BRP-Powertrain has informed us about following news.

Rework of new ignition coils with increased ignition voltage (for 125 Micro MAX to 125 MAX engines only)

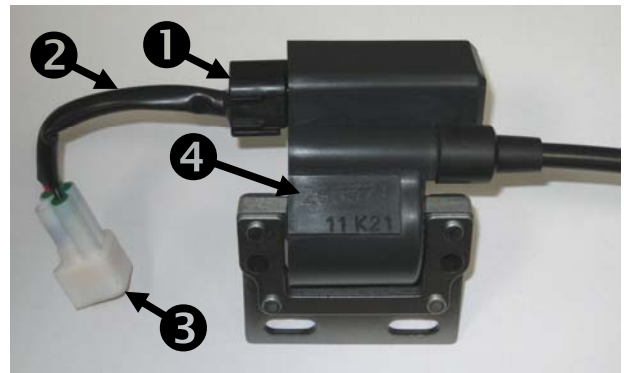
Due to a miscommunication with the supplier, BRP-Powertrain has received new ignition coils with increased ignition voltage but also with a deviation from the specification. BRP-Powertrain has investigated the possibility to rework these ignition coils and has defined a rework to correct the deviation and which is safe against later manipulation.

The rework consists of a manipulation inside the connector housing (1) of the ignition coil which in sequence requires the use of extension cables (2) and an external connector ((3) which is the same as on the ignition coil itself). After the rework the connector housing will be filled with non removable glue and ignition coils will be marked with a nail printer with the numbers "265571" (4). Every reworked ignition coil will be 100% tested to confirm the correct specification. Reworked ignition coils are 100% interchangeable without the need of any other modification.
